## ADDENDUM NO. 1

**DATE:** March 15, 2019

**RE:** BID NO. 19-95 – Vision Academy Paving, Drainage and Lighting Improvements

**OWNER:** EDINBURG CISD

EXHIBIT "A"  
FENCE DESCRIPTION

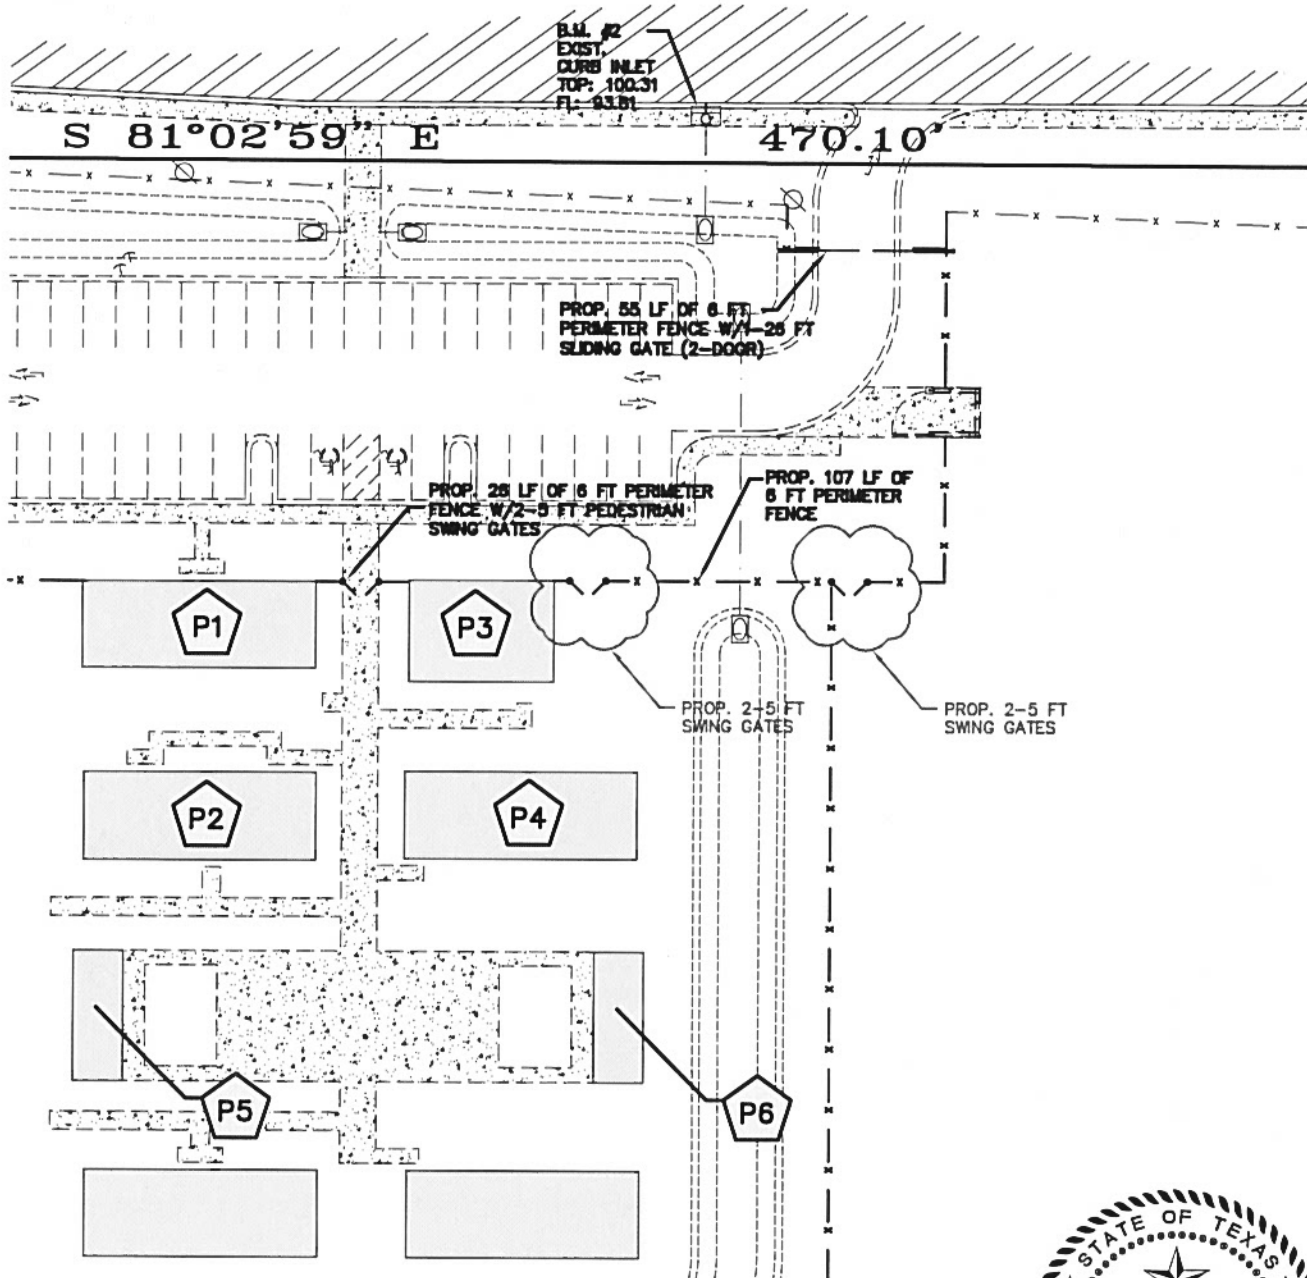
1. Plan Sheet 8 of 20 – See attached Detail for Gate.
